CRA Urban Design Overlay District- City Staff and Community Comments

CITY STAFF COMMENTS			
Commentator	Referenced Section	Comment	Response
Public Works	2.2-2.4	Is this document going to trump the LDC entirely?	No, the document will not trump the LDC entirely. Where a conflict exists between the Overlay and the underlying land development regulations, the Overlay will prevail. The Overlay will not alter allowable land uses under the current zoning, however, it will, in some instances modify dimensional standards and provide additional clarifying language related to the existing zoning. The Overlay's provisions will be limited to the Urban Core, Westside and Eastside Redevelopment Areas, excluding the City's existing Special Review Districts (SRD's) and the Port of Pensacola.
Public Works	Table 5.4.1.(D)	Tree cannot reduce required width for 5' wide pedestrian path.	Correct, trees cannot reduce the required width for a 5' wide pedestrian path. All ADA regulations must be adhered to. Table 5.4.1.(D) does not supersede ADA, not does any other section of this Overlay.

Figure 5.6.2: Encroachment for Arcades & Colonnades Illustrated**Figure 5.6.3: Encroachment for Galleries Illustrated**

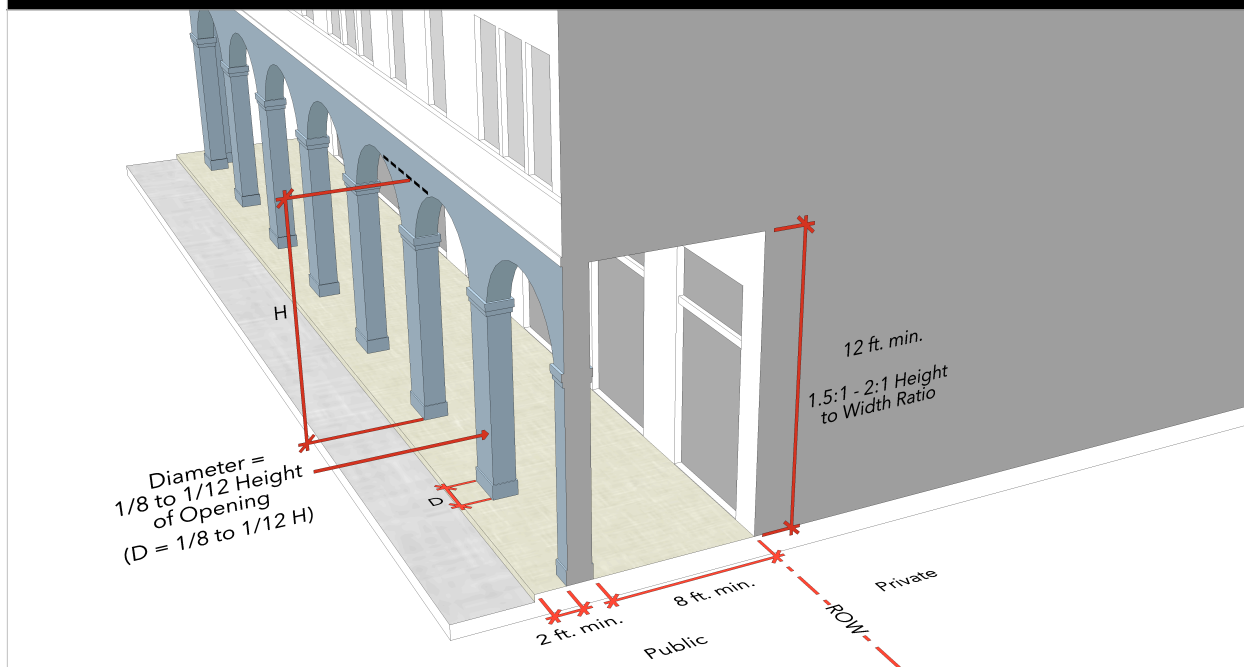
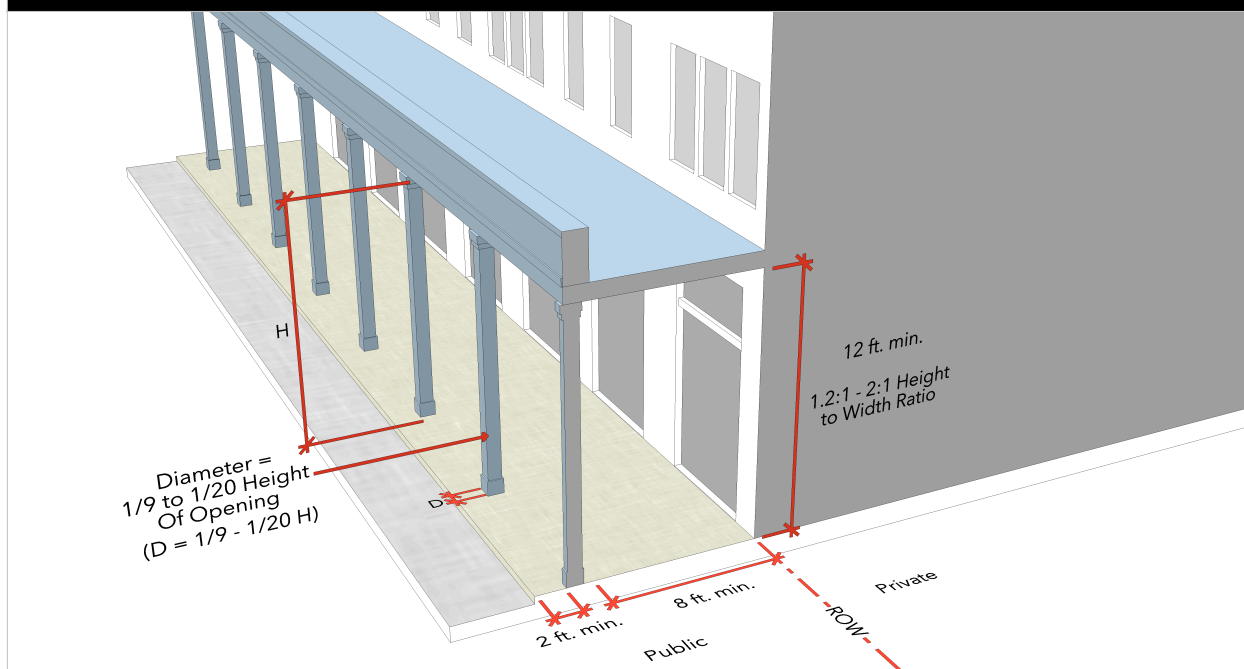
Charles Washington	Table 5.4.1 and Figures 5.6.2 and 5.6.3	Missing Tables or Figures. The draft has several missing (not included) tables or figures. Tables are missing on pages 17 and 18. Figures are missing on page 24.	Thank you for your comments.
Charles Washington	Tables 5.3.1-5.3.5 and Figure 5.6.1	Properly labeling or identifying the contents of a table or tables. See, for example, the table on pages 12, 14, 15, and 23.	Thank you for your comments. We will clarify.
Charles Washington	None Referenced	Substantive Content. 1. Deteriorating and Abandoned Housing. I was very surprised and disappointed that there is not one mention (that I could find) of keeping the CRA area free of deteriorating and abandoned buildings--private residence, commercial building or churches. The absence of such mention is to suggest that the intent is to preserve the area with its historic blight of abandoned and/or deteriorating buildings. This deserves at least a mention if not a policy statement or guideline to prevent such or to eliminate such buildings,	One of the CRA's main purposes is to remove and eradicate blight within the redevelopment areas. We will add a statement to the Intent section of the Overlay establishing that one of the goals of the design standards is to support the removal of blight within the redevelopment areas. The overlay, in and of itself, however cannot remove deteriorating and abandoned housing, but it can support redevelopment of such within its boundaries.
